Bone Lake APM Public Review

Comments accepted through April 10, 2020

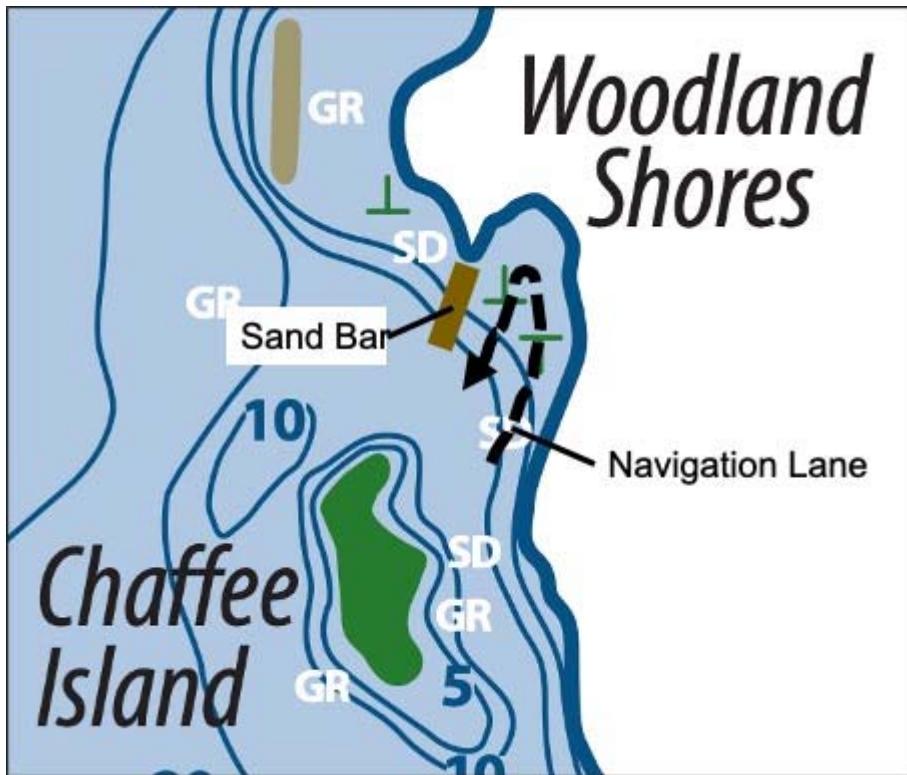
With regard to the bay being too shallow to navigate, I believe this concern could be addressed by following the same channel of navigation used by land owners along the bay. As shown in the illustration below, there is a sand bar that prevents entry into the bay from the West, but there is a nice navigation lane that parallels the shore if approached from the South.

I would ask that the entire bay be treated for CLP since it is designated for such treatment and is accessible.
